APPLICATION FOR AMENDMENT TO
OPERATING LICENSE

Indian Point Unit No. 3

Docket No. 50-286

July 8, 1977

TABLE 4.2-1 (Sheet 2 of 2)

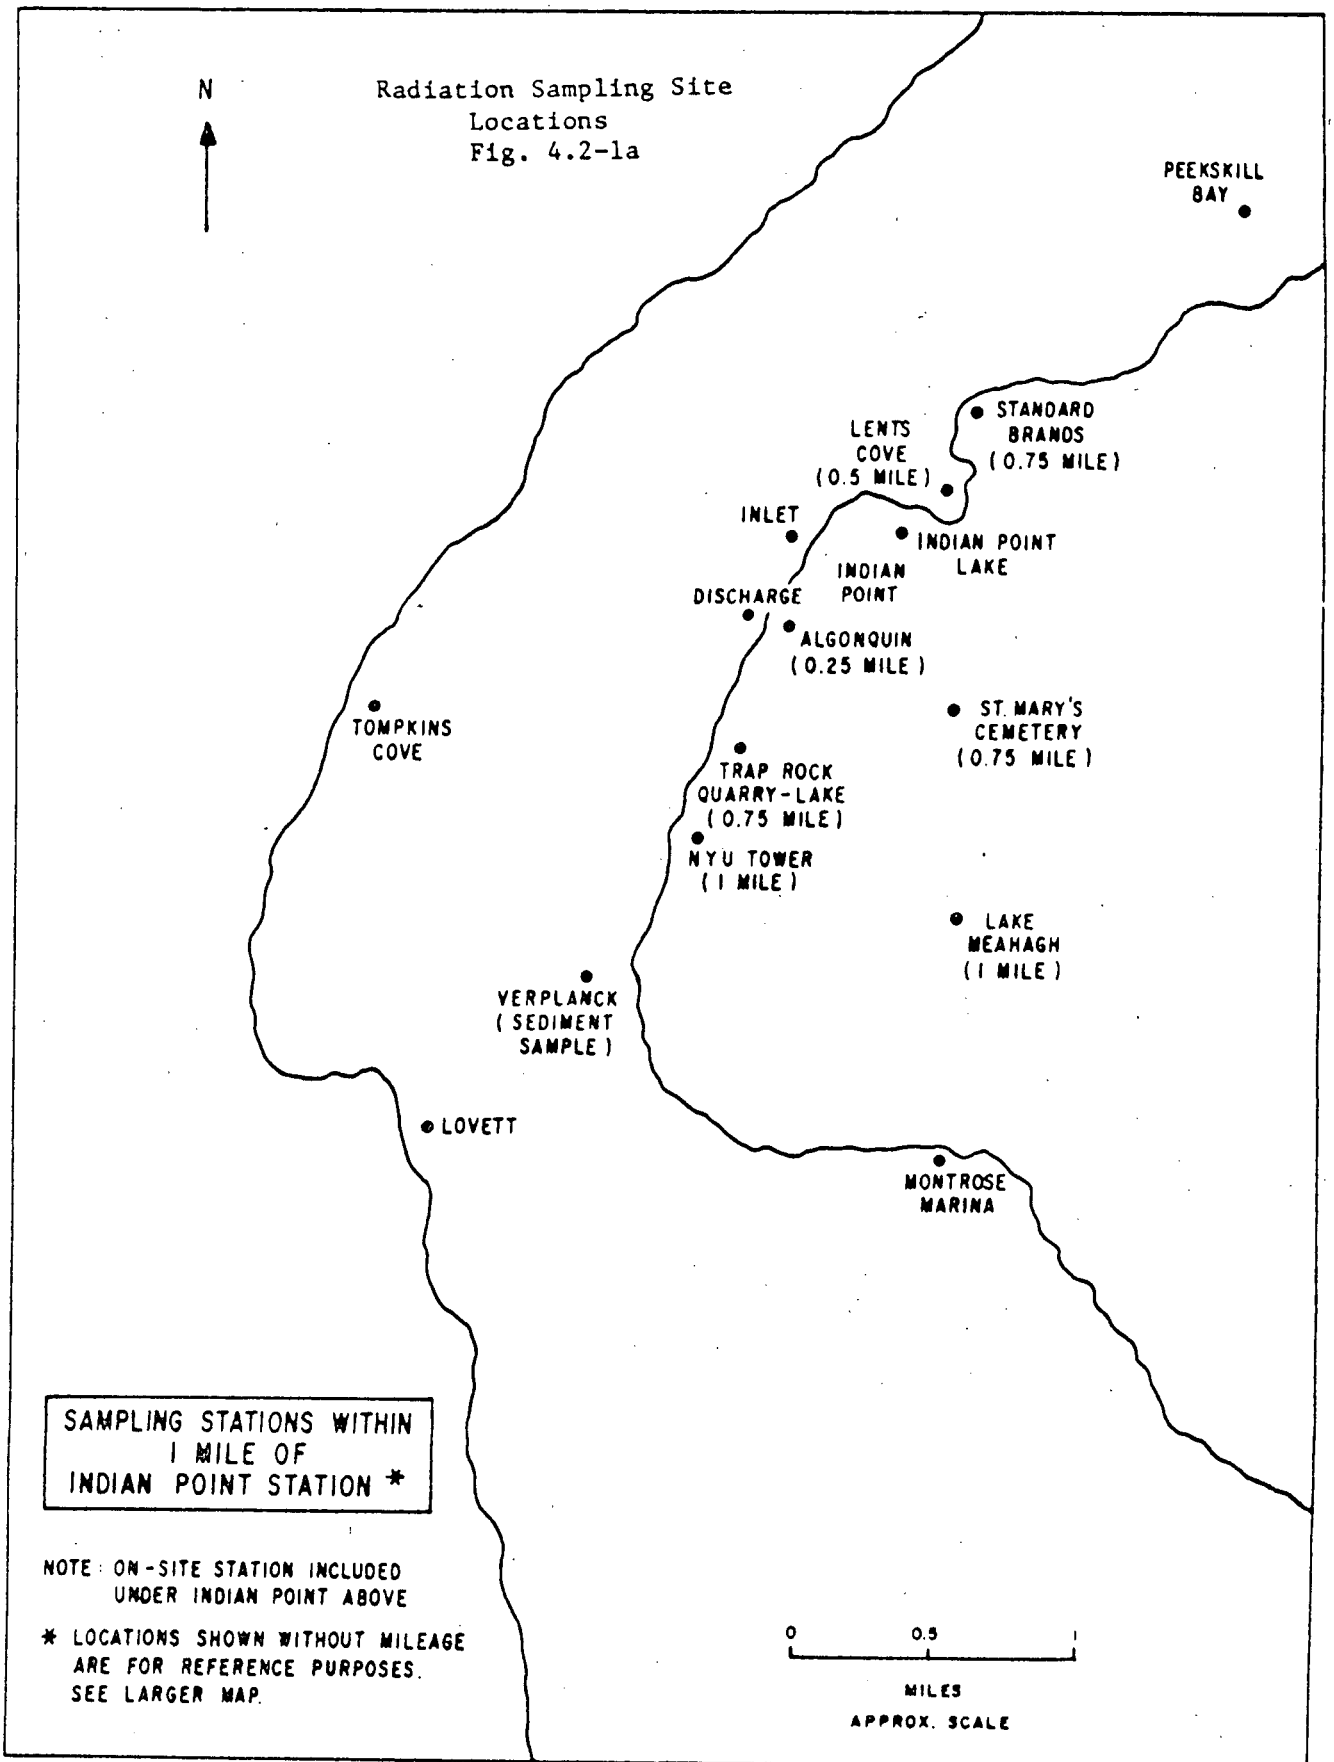
The proposed changes to the Environmental Technical Specification Requirements (ETSR) contained in Attachment A to this Application partially alter the program for sampling drinking water in the vicinity of the Indian Point Station.

Appendix B, Section 4.2 (see Table 4.2-1, Table 4.2-2 and Figure 4.2-1a) of the site Environmental Technical Specification Requirements contained in Appendix B to the Indian Point Unit No. 3 license requires that a well water sample be collected at sample station point 26 at Verplanck once per calendar quarter. However, the majority of the people living in Verplanck have now sealed off their wells and obtain their drinking water from the New York City Aqueduct. Therefore, a sample of the aqueduct water would be more representative of drinking water for persons living in the area than that of a well water sample.

In view of the above, the Verplanck sample location should be eliminated from the Technical Specifications and replaced with a requirement to sample drinking water from the New York City Aqueduct.

16. Milk	Selected locations of cows as determined from Spec. 4.2.1.2 Points 39, 40 and 42	Grab samples.	Monthly (when in pasture)	GSA, ⁸⁹ Sr, ⁹⁰ Sr, ¹³¹ I, ¹³⁴ Cs, ¹³⁷ Cs.

17. Grass***	Same as item 16.	Same as item 16.	Same as item 16.	Same as item 16.
18. Leafy Green Vegetables**** (Food Products)	Appropriate locations in critical wind sectors	Grab samples at point of source.	At time of harvest.	GSA, ¹³¹ I
